Access Compliance Report

Public Rights-of-Way

Intersection ID: 53924	Main Street: RORY_GLEN_LN	Cross Street: BRITTONDALE_LN	Location: NW
ADA ID: 63F40910E9ED	Ramp Type: BlendTrans1	Initial Pass/Fail: Fail	Overall Compliance: No
Severity Score: 10			
Codes/Mitigation Info/Possible Solution		Field Measurements/Component Compliance

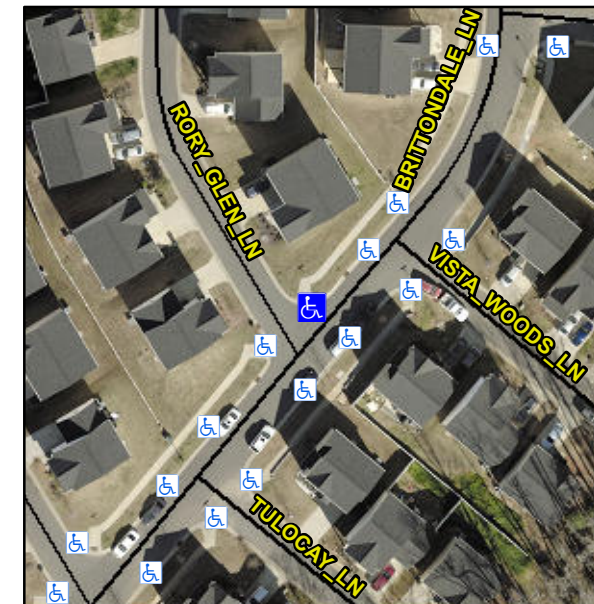
NO LT SW

Not Found, R304.5.1, R304.5.3

Compliance	Description	Data	Compliance	Description	Data
N/A	Ramp Length (in)	95.0	Yes	BlendTrans Slope (%)	2.7
No	Ramp Width (in)	47.5	No	BlendTrans XSlope (%)	5.0
N/A	Flare Type LT	N/A	N/A	Flare Type RT	N/A
N/A	Flare Slope LT (%)	N/A	N/A	Flare Slope RT (%)	N/A
N/A	Flare Traversable LT?	N/A	N/A	Flare Traversable RT?	N/A
N/A	Landing Length (in)	N/A	N/A	DWS Provided?	N/A
N/A	Landing Width (in)	N/A	N/A	DWS Contrast?	N/A
N/A	Landing Slope (%)	N/A	N/A	DWS Length (in)	N/A
N/A	Landing X Slope (%)	N/A	N/A	DWS Full Width?	N/A
N/A	Landing Curb? (Y/N)	N/A	N/A	DWS Offset (in)	N/A
N/A	Shared Landing?	N/A			
N/A	Gutter Ponding?	N/A	N/A	Gutter Slope (%)	N/A
N/A	Gutter Lip Ht (in)	N/A	N/A	Gutter X Slope (%)	N/A
N/A	Painted X Walk1?	No	N/A	Painted X Walk2?	No
	X Walk 1 Direction	To SW		X Walk 2 Direction	To SE
	X Walk 1 Width (in)	N/A		X Walk 2 Width (in)	N/A
	X Walk 1 Slope (%)	5.1		X Walk 2 Slope (%)	2.1
	X Walk 1 X Slope (%)	1.2		X Walk 2 X Slope (%)	0.9

N/A	Ramp inside XWalk1?	N/A	N/A	Ramp inside XWalk2?	N/A
	Road Slope (%)	5.0		Clear Space?	N/A
	Road X Slope (%)	2.2	N/A	Clear Space to XWalk (in)	N/A
N/A	Any Obstructions?	N/A	N/A	Storm Grate/Utility Hazard?	N/A
	Obstruction Type			Storm Grate/Utility Type	
		N/A			N/A
			Yes	Surface Condition? (G/P)	Good
			No	Curb Slope (%)	6.5

Remove & Replace Curb Ramp With Two New Directional Ramps or Equivalent.
